APPLICATION NO.	FILING DATE	FIRST NAMED INVENTOR	ATTORNEY DOCKET NO.	CONFIRMATION NO.	
10/761,856	01/20/2004	Olaf Kruse	RICHT-45041	3074	
26252 7	590 11/21/2005		EXAMINER		
KELLY LOWRY & KELLEY, LLP 6320 CANOGA AVENUE			DOLINAR, ANDREW M		
SUITE 1650	AAVENUE	,	ART UNIT	PAPER NUMBER	
WOODLAND	HILLS, CA 91367	•	3747	-	
			DATE MAIL ED. 11/21/2001	DATE MAIL ED: 11/21/2005

Application No.	Applicant(s)				
	10/761,856	KRUSE ET AL.				
Office Action Summary	Examiner	Art Unit				
	Andrew M. Dolinar	3747				
The MAILING DATE of this communication appears on the cover sheet with the correspondence address Period for Reply						
A SHORTENED STATUTORY PERIOD FOR REPLY IS SET TO EXPIRE 3 MONTH(S) OR THIRTY (30) DAYS, WHICHEVER IS LONGER, FROM THE MAILING DATE OF THIS COMMUNICATION. - Extensions of time may be available under the provisions of 37 CFR 1.136(a). In no event, however, may a reply be timely filed after SIX (6) MONTHS from the mailing date of this communication. - If NO period for reply is specified above, the maximum statutory period will apply and will expire SIX (6) MONTHS from the mailing date of this communication. - Failure to reply within the set or extended period for reply

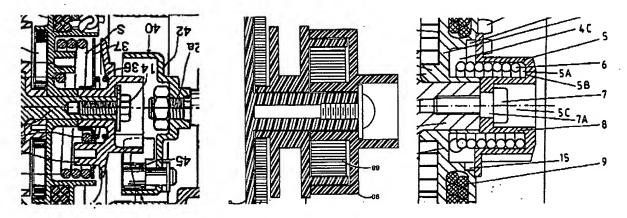
Applicant's arguments have been fully considered but they are not persuasive. The similarity of the element 8 identified as the "bushing or sleeve" and corresponding elements of the prior art is evident from the below side by side comparison applicant's starter (right) with those of Kawasaki et al (left) and Liesure et al (center).

The claims set forth no detail of structure that would serve to distinguish over the references as applied. One must bear in mind that, especially in nonchemical cases, the words in a claim are generally not limited in their meaning by what is shown or disclosed in the specification. See, e.g., *Liebel-Flarsheim Co. v. Medrad Inc.*, 358 F.3d 898, 906, 69 USPQ2d 1801, 1807 (Fed. Cir. 2004).
